Lots 1 & 5 Broadhurst Crescent, Bateman
Proposed Child Care Centre

TRANSPORT IMPACT STATEMENT

March 2023

Figure 25: End clearance requirements for on-street parking (AS2890.5)

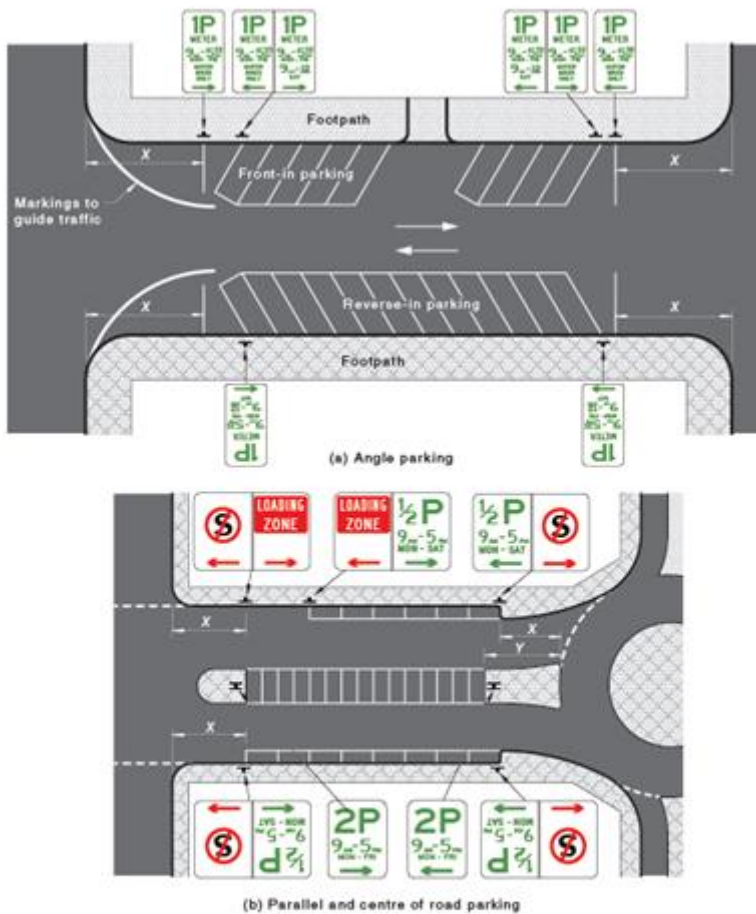
Remove single parallel bay on Islip Ct. (Amended Plans Required)

Project: U21.064 - Lots 1&5 Broadhurst Crescent, Bateman
 Proposed Child Care Centre
 Drawing Title: Stopping Sight Distance Assessment
 AGRID Part 3 - Geometric Design

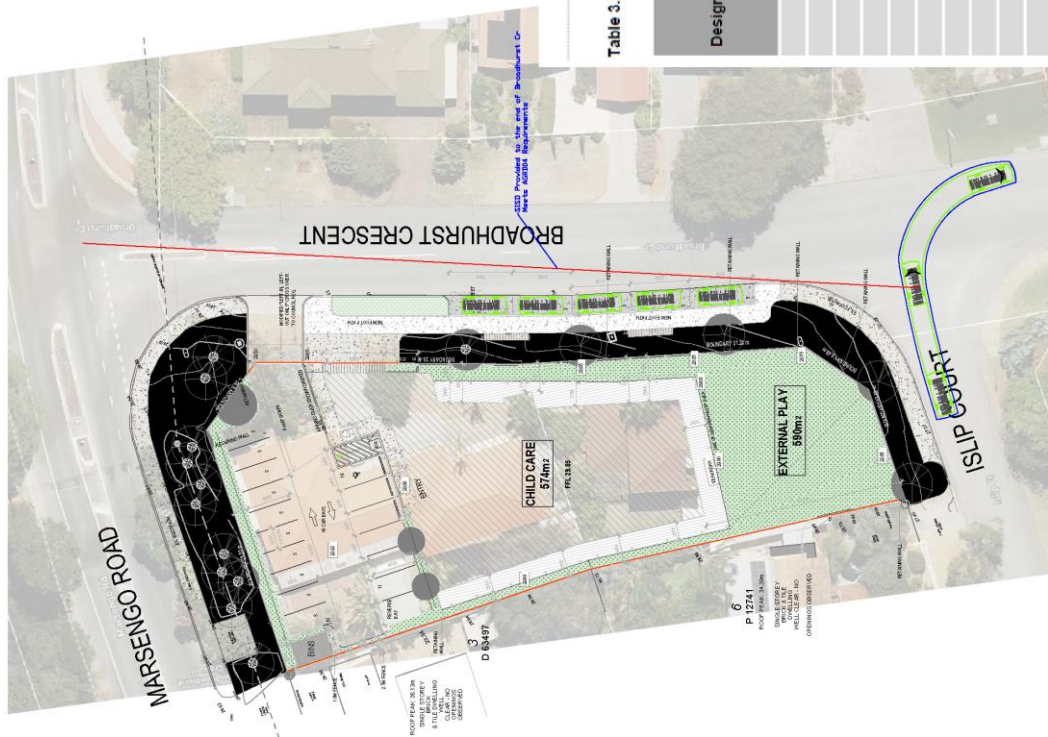
The required Stopping Sight Distance is 62m. This is considered a sufficient distance for visibility between outbound traffic at the crossover and northbound traffic on Broadhurst Crescent. To achieve the required SSD, two on-street parking bays needed to be removed from the proposed development plans.

As detailed in sketch sk02 in Appendix B, there is over 70m sight distance, which exceeds the minimum SSD requirements.

Revision notes:
 Rev: 1 Date: 25/02/2023
 Note: Reaction time = 2.5sec Vehicle speed = 50km/h Stopping Sight Distance (SSD) = 62m
 Assumed design speed of 50km/h is conservative. Northbound traffic terminates at a T-intersection and therefore vehicles will be decelerating on approach to the crossover location.
